Location/WOs: Walmart Store #2403 in Puyallup, WA
Wallace Project No. 2210879, Client Project No. 37554607

Purpose: Preconstruction Meeting

Preconstruction Meeting Photos

KEYPLAN

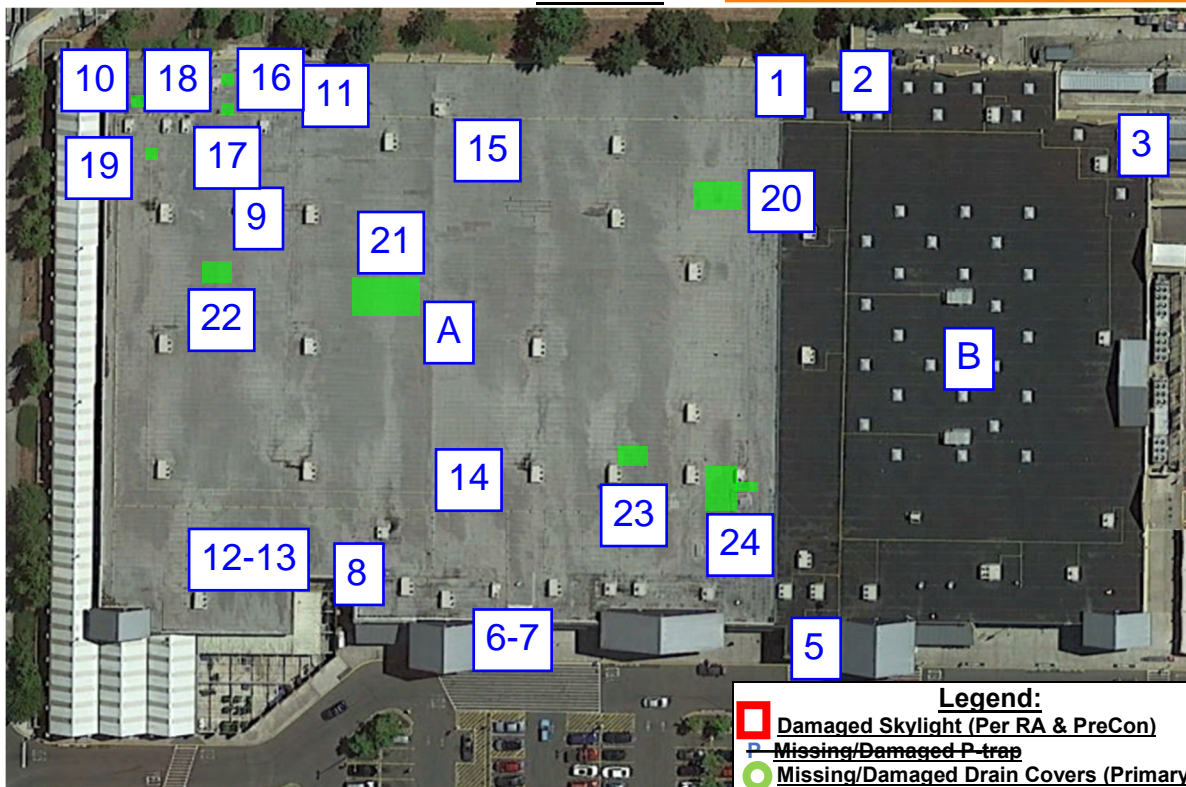
SEE SEPARATE ROOF LAYOUT SHEET DEFINING THE AMOUNT OF INSULATION TO BE REPLACED AT EACH AREA PER ENGINEER. 10/03/2022 DL.
